Design Review Board – Neighborhood Panel

Agenda Workshop

**Planning Staff Report to
Design Review Board - Neighborhood
May 24, 2022**
for the June 2, 2022 Public Hearing

**Planning Staff Report to
Design Review Board - Neighborhood
May 17, 2022**
for the June 2, 2022 Public Hearing

Existing Left Elevation w/ Demo
1/4" = 1'-0"

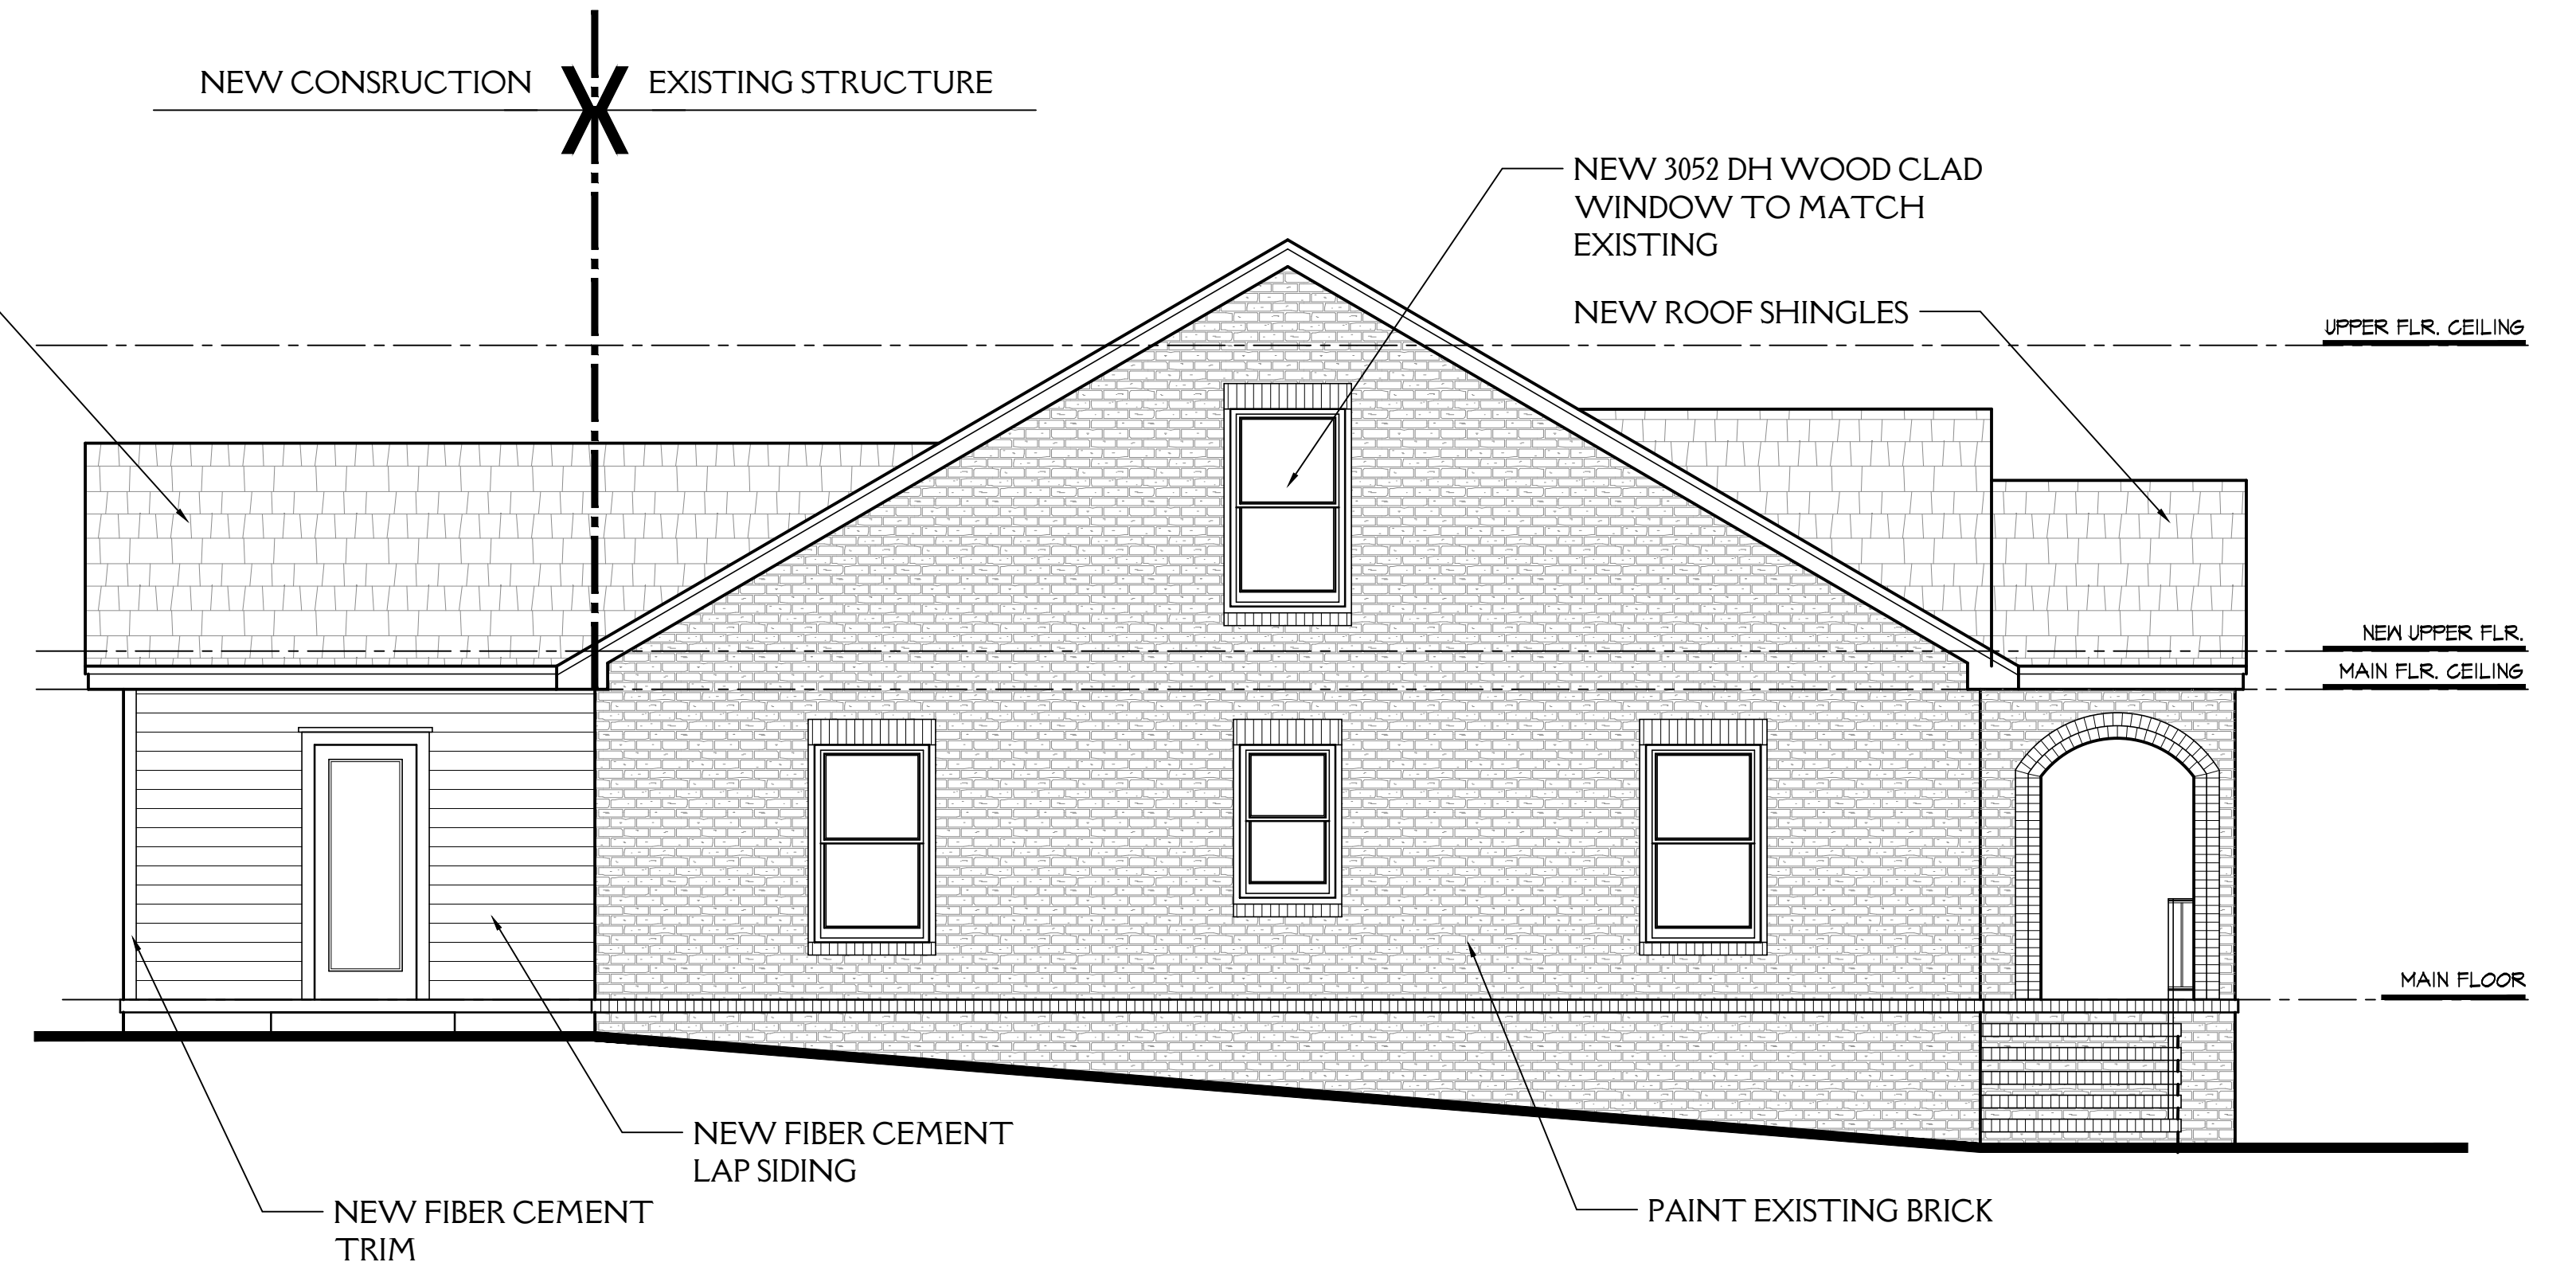
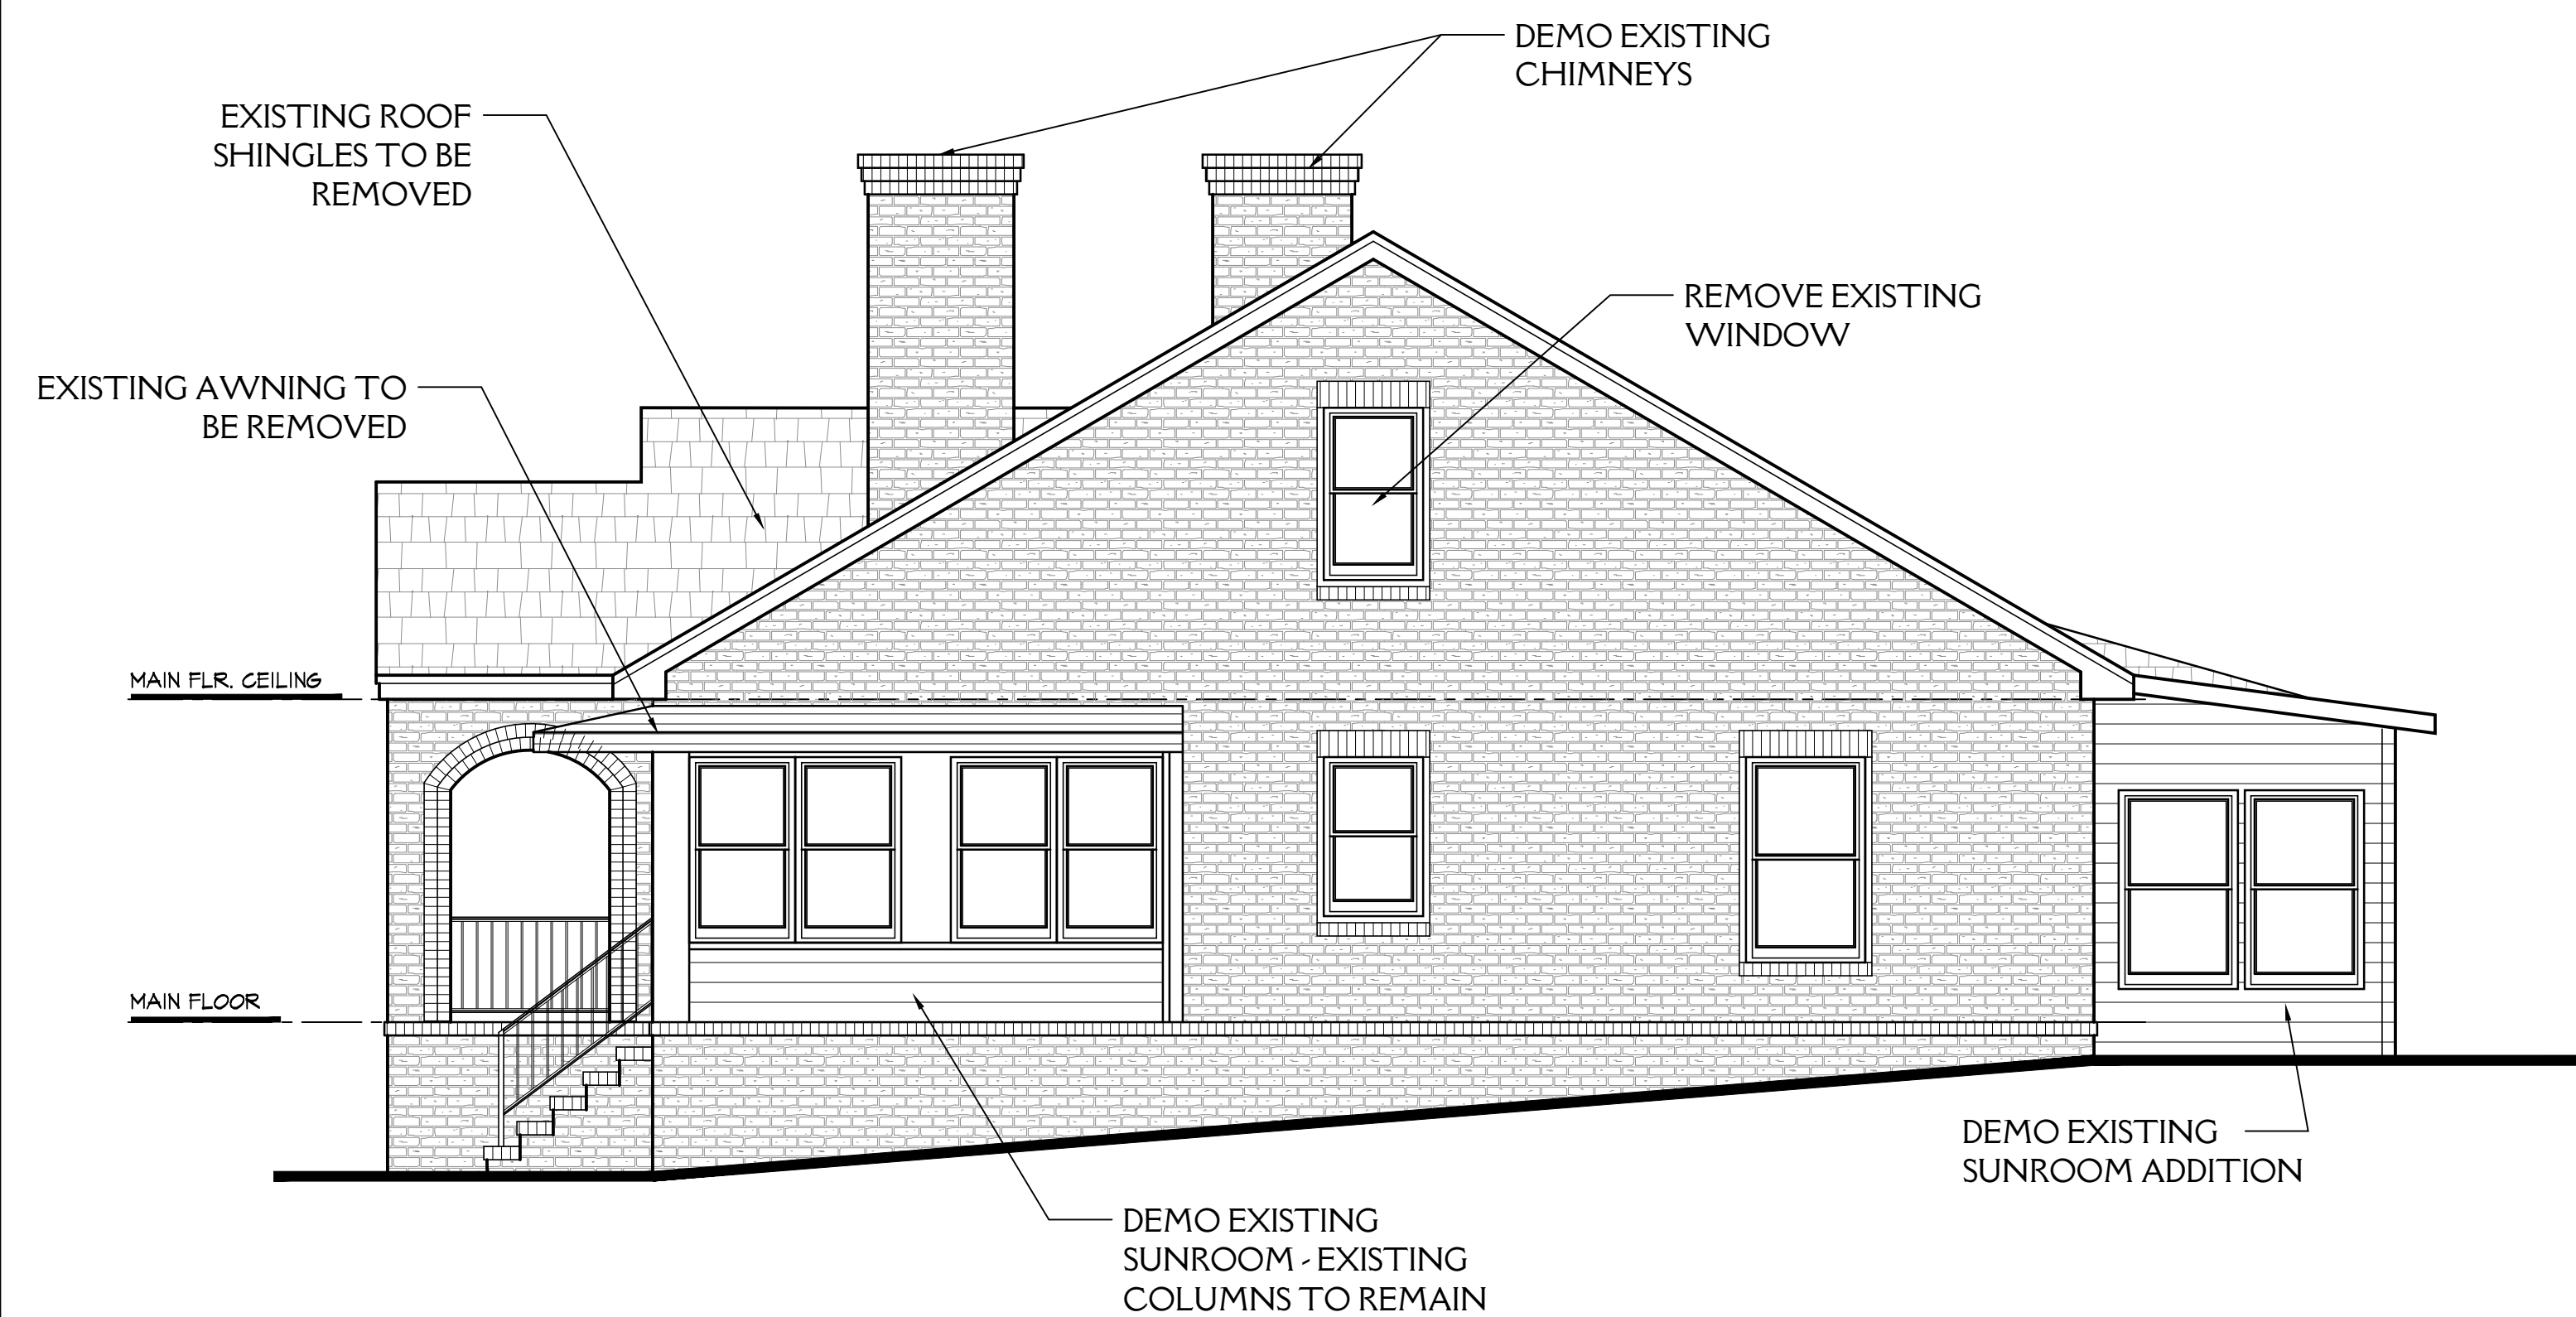
The proposed materials of Hardie Plank are suitable for the new rear addition, but the historic brick should be maintained and preserved on the remainder of the house and not painted as is proposed. HR.9 Masonry Construction, recommends that brick that was not painted historically should not be painted.

Staff finds that removal of the chimneys is not compatible with the design guidelines outlined in Chapter 9. Overbrook Historic District. The introduction specifically calls out chimneys as contributing to the historic district and should be maintained. While Design Guidelines do not dictate interior modifications and would therefore allow for the proposed removal of the fireplaces the existing historic chimneys should be preserved. Structural engineering efforts should be made to maintain the existing elevation of the house.
